I-66 North Bypass

VALUE ENGINEERING STUDY
for the
Kentucky Transportation Cabinet

Final Report

February 6, 2003

TYPICAL SECTION

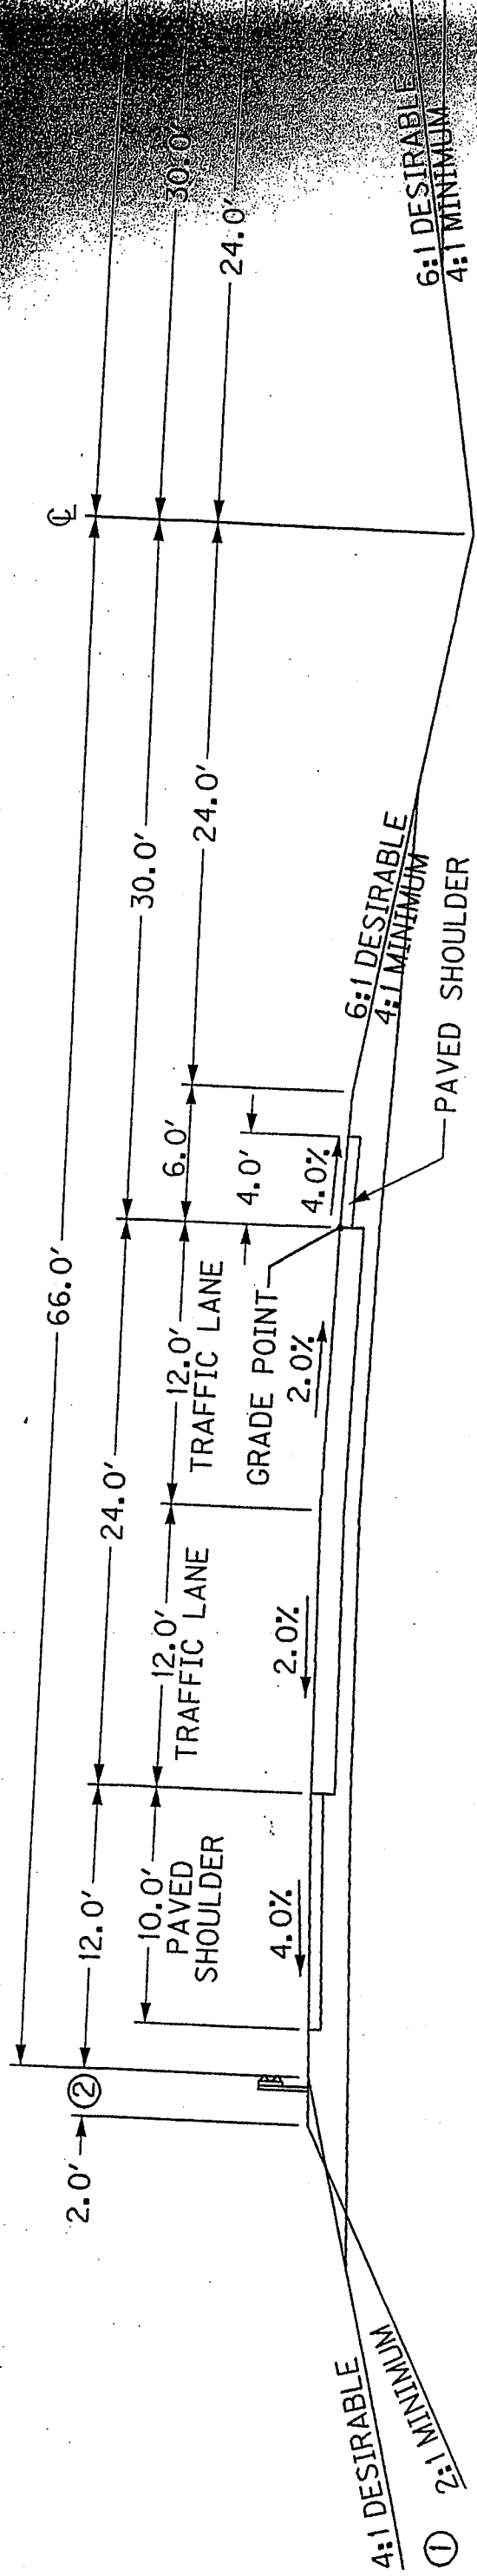
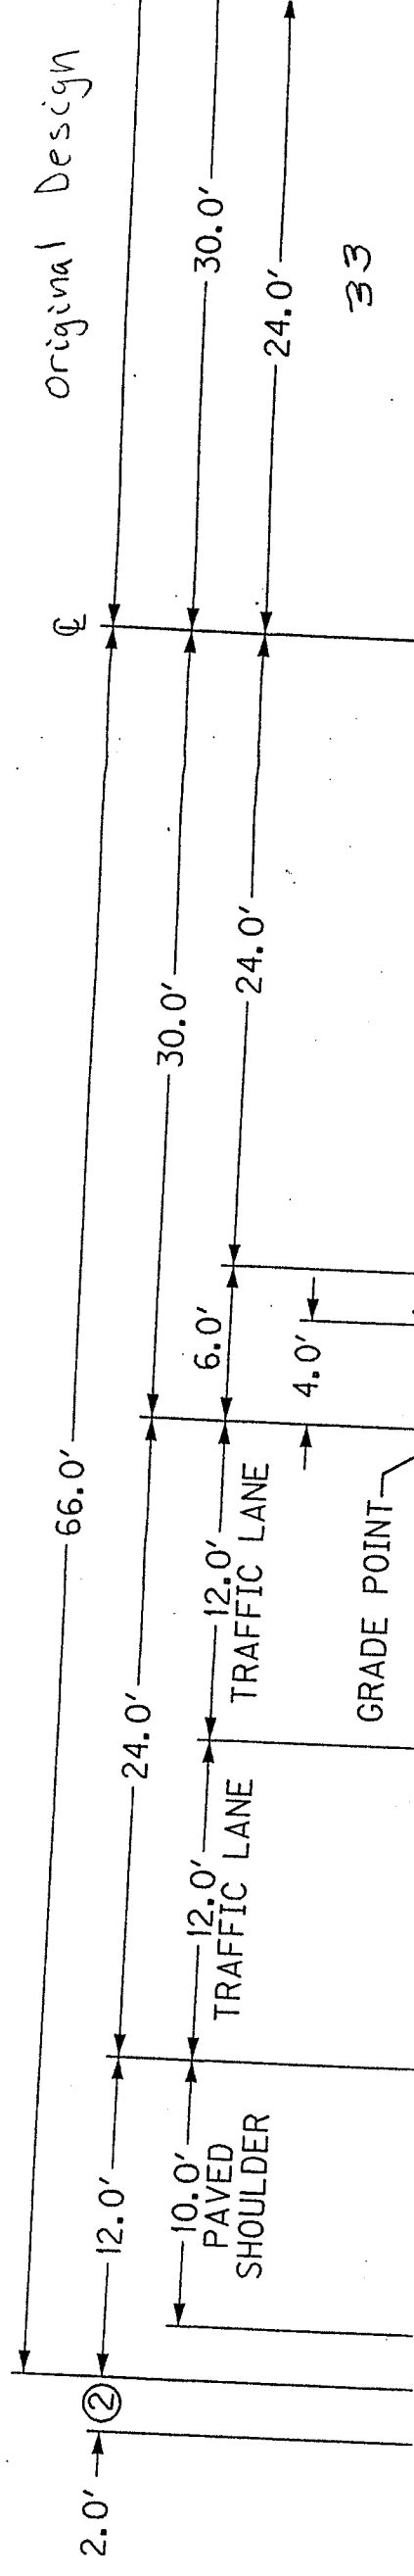
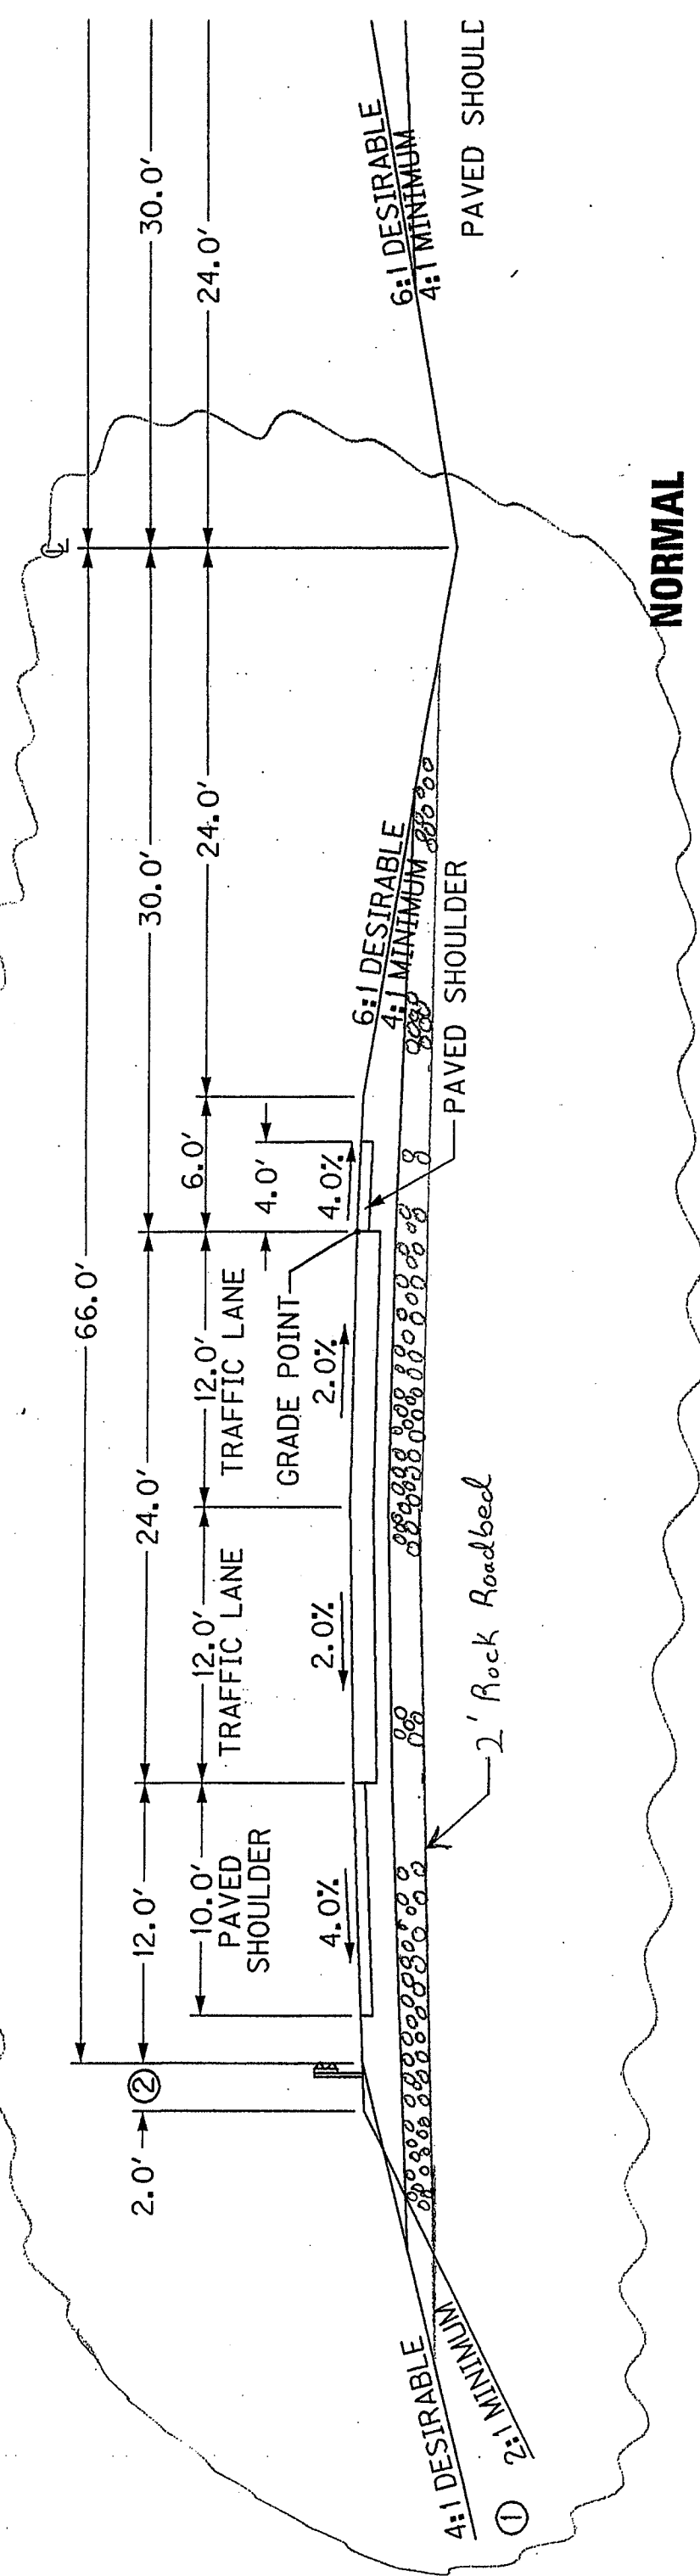
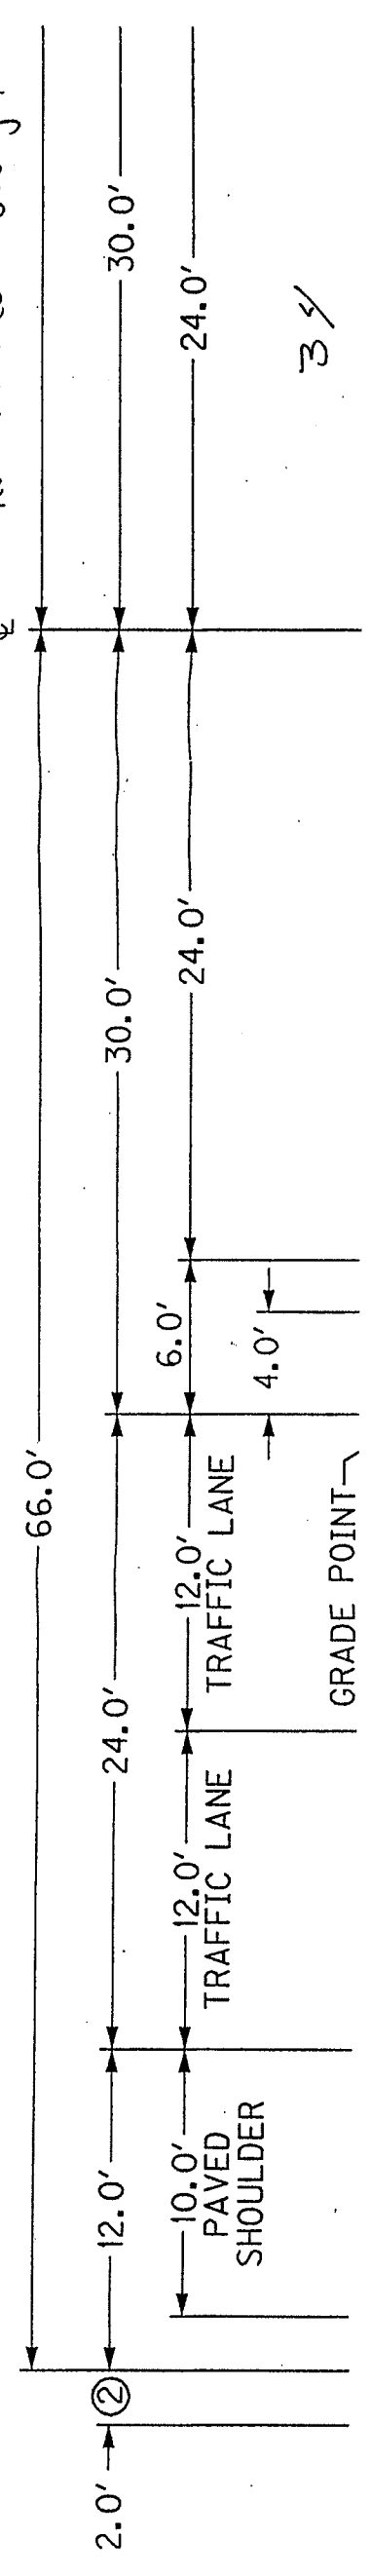
The profile grade for I-66 between stations a544+90 and a67780.12 creates a project requiring 676,390 cubic yards of borrow material.

Lower the profile grade to reduce the amount of embankment and create more excavation eliminating the need for material borrow, while at the same time providing the ability to build rock roadbed.

By lowering the profile grades it will be possible to reduce the amount of embankment and increase the amount of excavation. This will reduce the cost needed for the large amount of borrow material, as well as providing rock for a rock roadbed. The rock roadbed, in turn will add significant savings, by enabling reduction of the asphalt pavement depth.
